The Commission has issued the enclosed Amendment No. 48 to Facility Operating License No. DPR-58 for the Donald C. Cook Nuclear Plant, Unit No. 1. The amendment consists of changes to the Technical Specifications in response to your application transmitted by letter dated March 26, 1981.

This amendment revises the F_0 peaking factor limit.

Amendment No. 48
License No. DPR-58

SAFETY EVALUATION BY THE OFFICE OF NUCLEAR REACTOR REGULATION
RELATED TO AMENDMENT NO. 48 TO FACILITY OPERATING LICENSE NO. DPR-58

Figure 3.2.3a

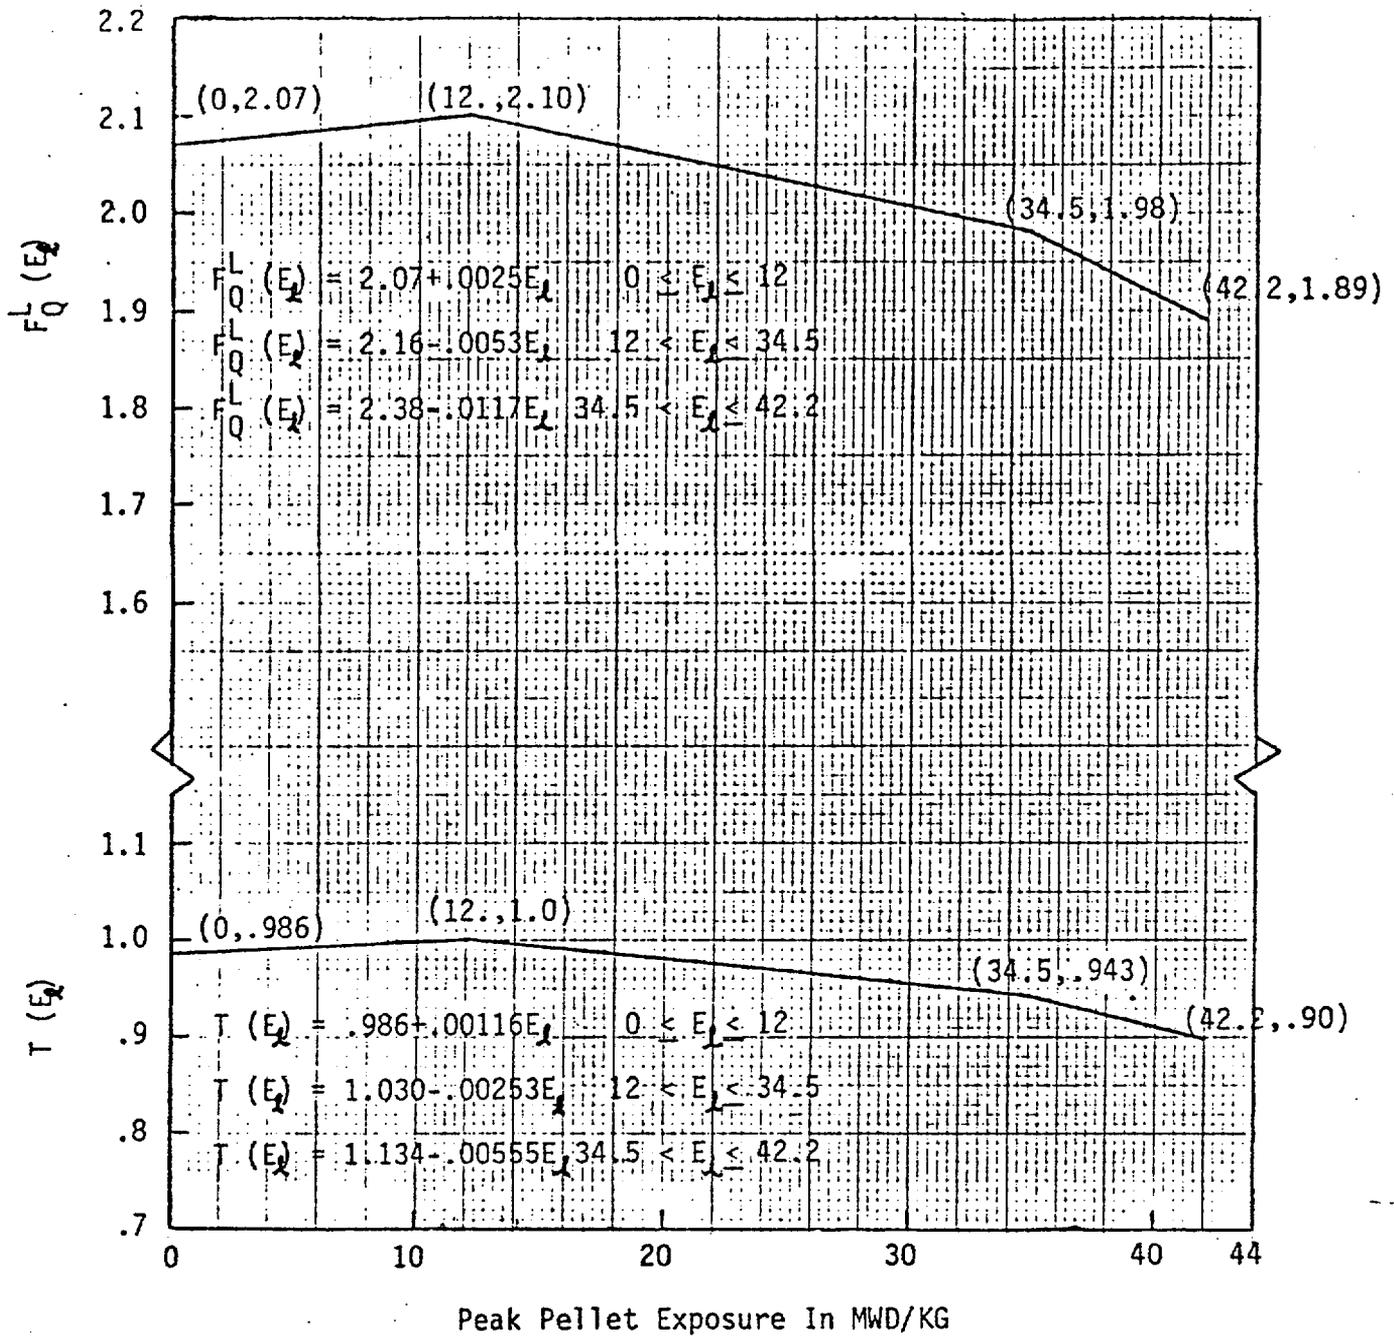
- e. F_{Qil}^{Meas} is the limiting total peaking factor in flux map i . The limiting total peaking factor is that factor with least margin to the $F_Q^L(E\bar{l})$ curve defined in Figure 3.2-3a for Exxon Nuclear Company fuel and in Figure 3.2-3b for Westinghouse fuel.

$T(E\ell)$ is the ratio of the exposure dependent $F_Q^L(E)$ to 2.10 and is defined in Figure 3.2-3a for fuel supplied by Exxon Nuclear Company and in Figure 3.2-3b for fuel supplied by Westinghouse Electric Corporation.

Exposure Dependent F_0 Limit, $F_0^L(E_2)$, and Normalized Limit $T(E_2)$ as a Function of Peak Pellet Burnup for Exxon Nuclear Company Fuel.
